August 23, 2004 :

ADDENDUM #1 for BASE BID #1

PROJECT: JLTC – Building #1 (Site Utilities) **DFCM Project # 04231480**
Camp Williams
Draper, UT 84065

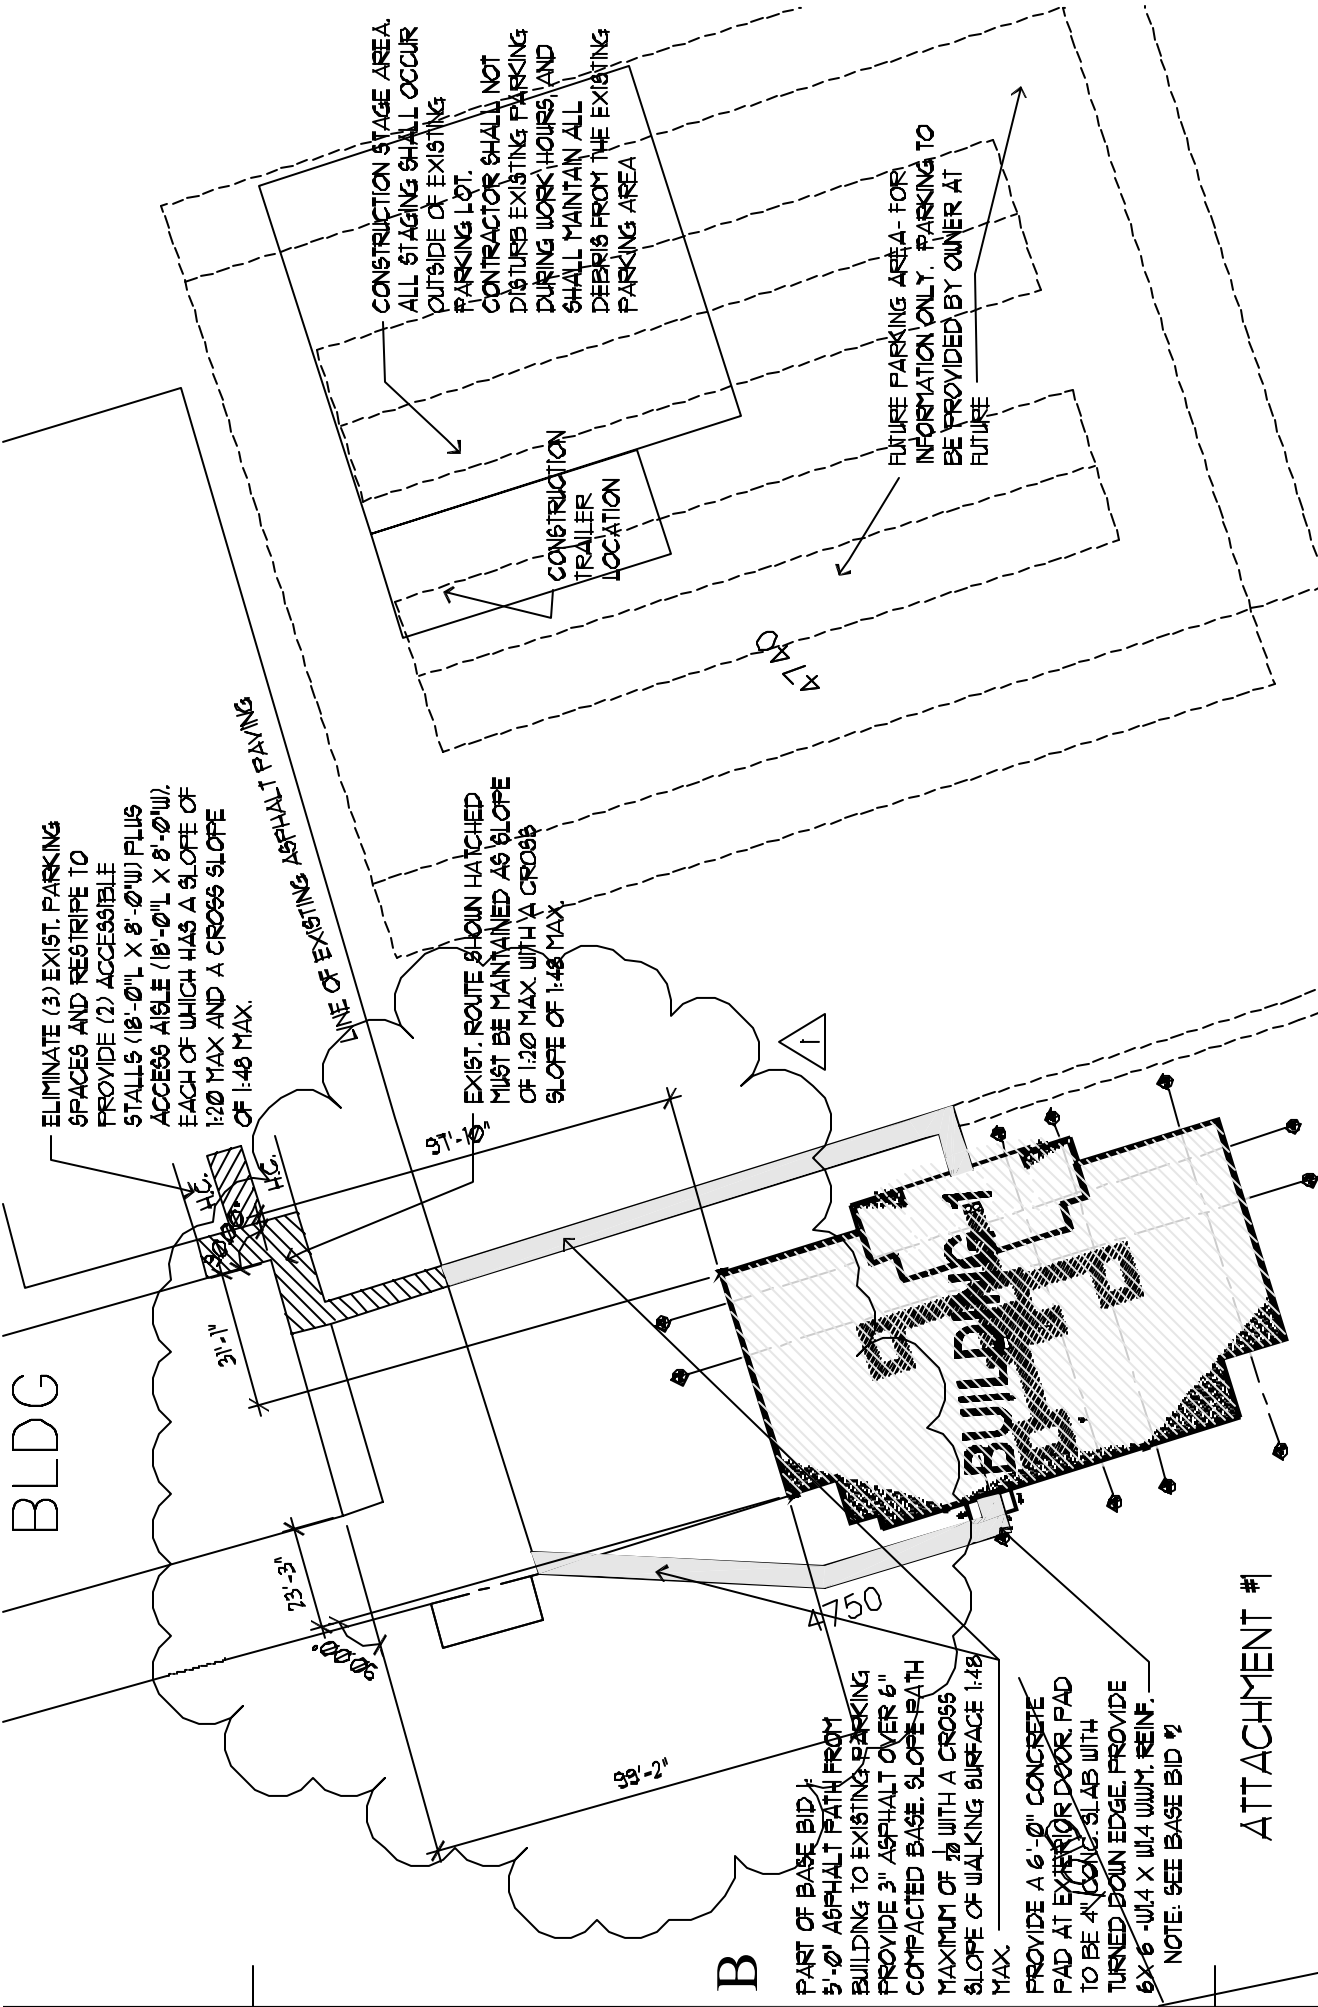
- 4.1. See the attached sheet #1 for building control data dimensions.
- 4.2. See the attached sheet #1 for addition of (2) accessible parking stalls.
- 4.3. See the attached sheet #1 for the revision of the concrete entry slabs that are part of Base Bid #2 and the asphalt walkways that are to be included in Base Bid #1.

B

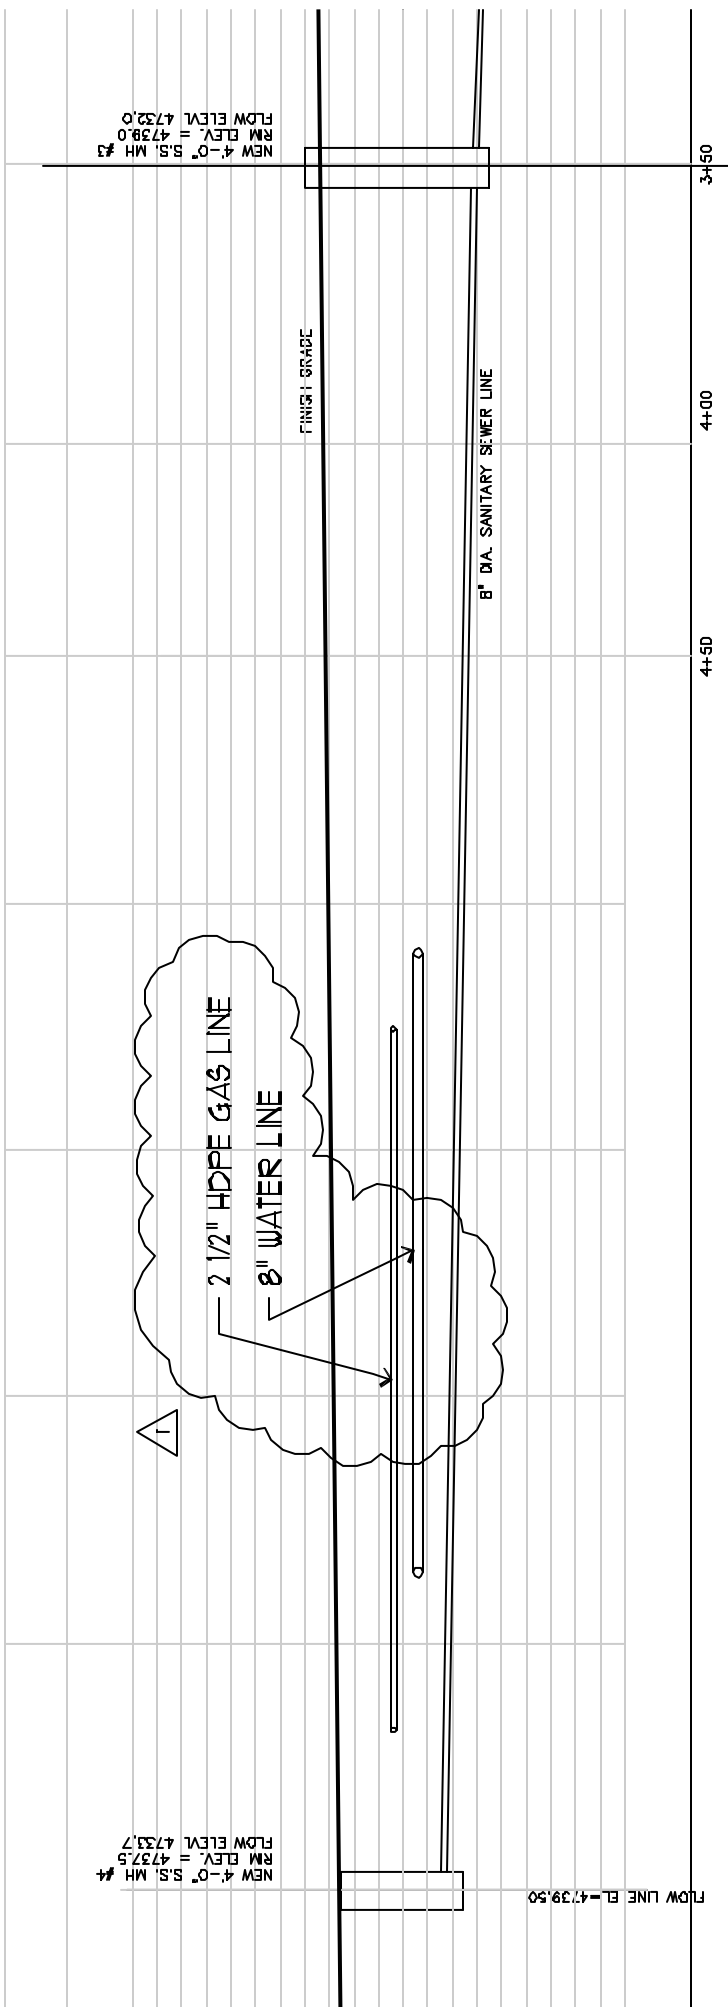
- 6.1. See the attached sheet #2 for pipe clarification.
